SITE PLAN FOR Y SPRINGS RD JUDISION COUNTY, GEORGIA

PETITION NO: Z-25

PROPOSED USE: Single-Family Subdivision

ZONING COMMENTS:

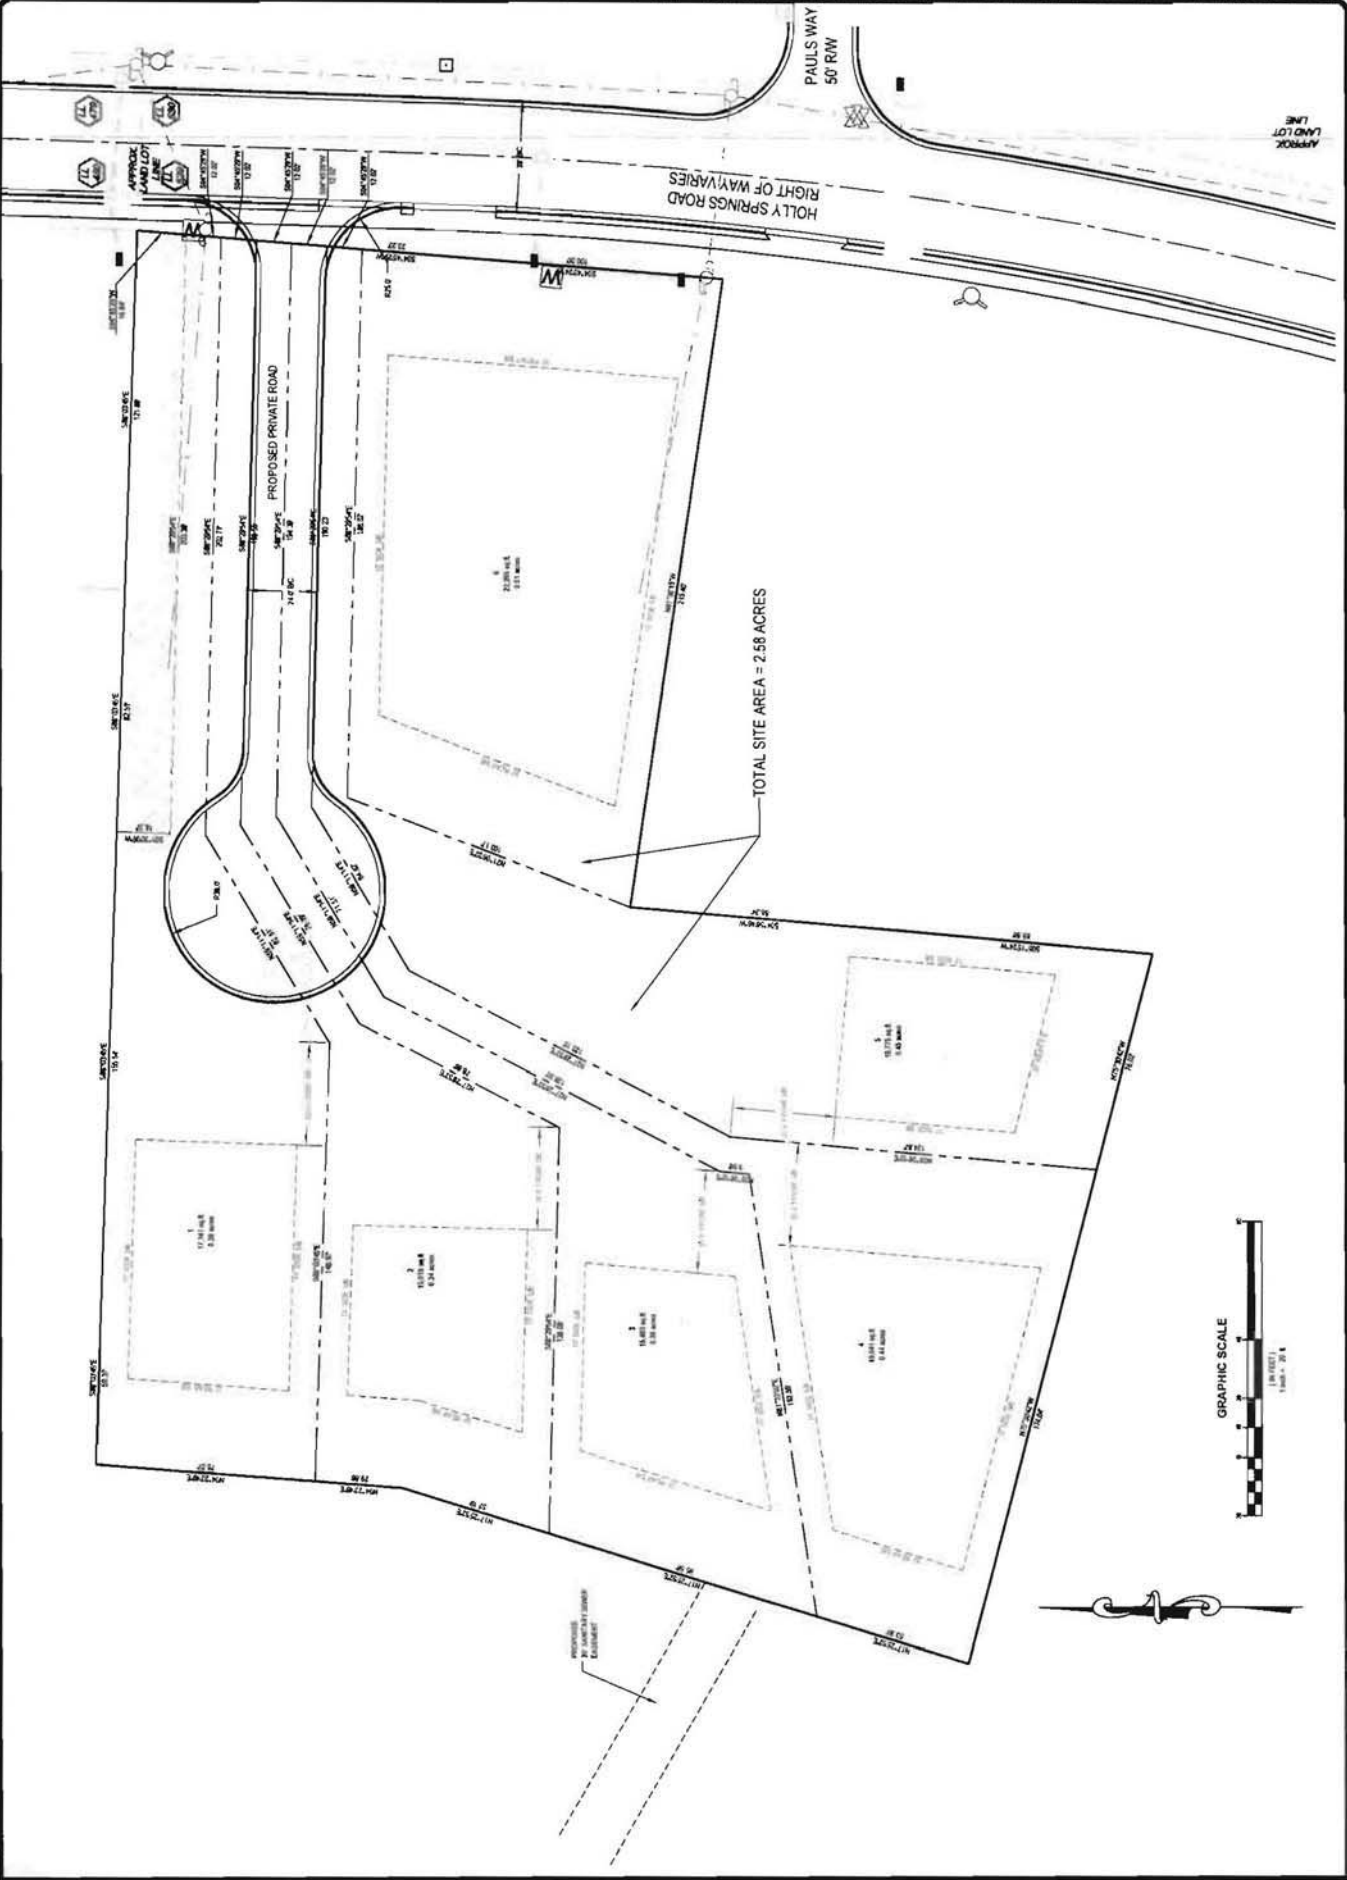
- Driveway must have a minimum 12' driving surface width with minimum 25' inside turning radius.
- Fully developed landscaping shall be at least 7'0" from center of drive (14' clear width) and 13'6" vertical clearance. (Indicate on plan minimum setbacks).
- Maximum grade shall not exceed 18%.
- Driveway must extend within 150' of the most remote portion of the structure.
- Driveway is limited to 1000' maximum from roadway unless an approved turn-around is provided. (See note below.)
- Driveway must support 25 Tons (50,000 lbs.)
- Provide emergency access to all gates securing Fire Dept. access with a minimum 12'-0" clear width
- Hydrant within 500' of remote structure, minimum 6" main*
(Required Flow: 1000 gpm @ 20 psi)
- Fire Flow Test from closest existing hydrant*
(Required Flow: 1000 gpm @ 20 psi)

1. Based on drainage concerns in the adjacent subdivision to the west, all impervious runoff must be directed to the proposed detention pond. Adequate capacity of the existing storm system along Holly Springs Road to receive the proposed pond discharges must be verified at Plan Review. The detention pond must be placed on it's own parcel with adequate access from the public right-of-way.

Recommend applicant consider entering into a development agreement pursuant of O.C.G.A. 36-71-13 for dedication of the following system improvements to mitigate traffic concerns: a) donation of right-of-way on the west side of Holly Springs Road, a minimum of 50' from the roadway centerline.

Recommend replacing any disturbed sidewalk along Holly Springs Road frontage and adding wheelchair ramps at the proposed intersection.

Recommend applicant verify that minimum intersection sight distance is available and if it is not, implement remedial measures, subject to the Department's approval, to achieve the minimum requirement.
